Access Compliance Report

Public Rights-of-Way

Intersection ID: 30033	Main Street: DILLARD_RIDGE_DR	Cross Street: SOUTHWIND_DR	Location: NW
ADA ID: 97C0D6F71D29	Ramp Type: Combination1Diag	Initial Pass/Fail: Fail	Overall Compliance: No
		Severity Score: 0

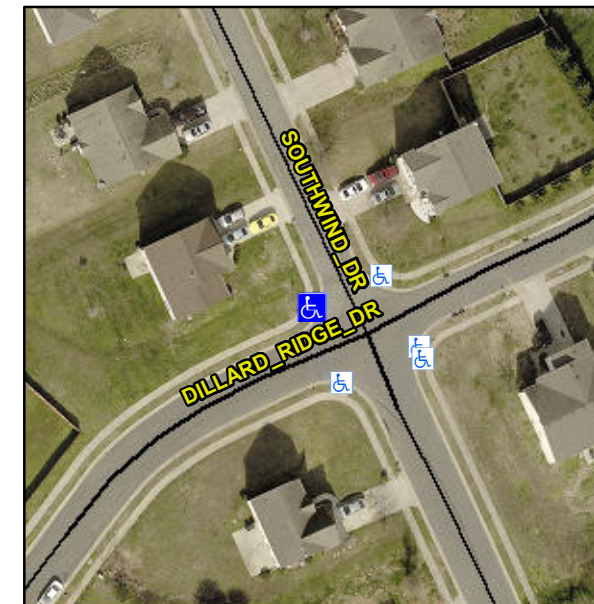
Not Found, R304.5.1, R304.2.2, R304.5.3

Compliance	Description	Data	Compliance	Description	Data
N/A	Ramp Length LT (in)	38.5	N/A	Ramp Length RT (in)	38.5
No	Ramp Width LT (in)	47.0	Yes	Ramp Width RT (in)	48.0
Yes	Ramp Slope LT (%)	7.7	Yes	Ramp Slope RT (%)	8.2
No	Ramp XSlope LT (%)	2.8	Yes	Ramp XSlope RT (%)	0.3
N/A	Ramp Length (in)	47.5	No	Ramp Slope (%)	13.6
Yes	Ramp Width (in)	64.0	No	Ramp XSlope (%)	7.8
N/A	Flare Type LT	N/A	N/A	Flare Type RT	N/A
N/A	Flare Slope LT (%)	N/A	N/A	Flare Slope RT (%)	N/A
N/A	Flare Traversable LT?	N/A	N/A	Flare Traversable RT?	N/A
N/A	Landing Length (in)	N/A	N/A	DWS Provided?	N/A
N/A	Landing Width (in)	N/A	N/A	DWS Contrast?	N/A
N/A	Landing Slope (%)	N/A	N/A	DWS Length (in)	N/A
N/A	Landing X Slope (%)	N/A	N/A	DWS Full Width?	N/A
N/A	Landing Curb? (Y/N)	N/A	N/A	DWS Offset (in)	N/A
N/A	Shared Landing?	N/A			
N/A	Gutter Ponding?	N/A	N/A	Gutter Slope (%)	N/A
N/A	Gutter Lip Ht (in)	N/A	N/A	Gutter X Slope (%)	N/A
N/A	Painted X Walk1?	No	N/A	Painted X Walk2?	No

Remove & Replace Curb Ramp With Two New Directional Ramps or Equivalent.
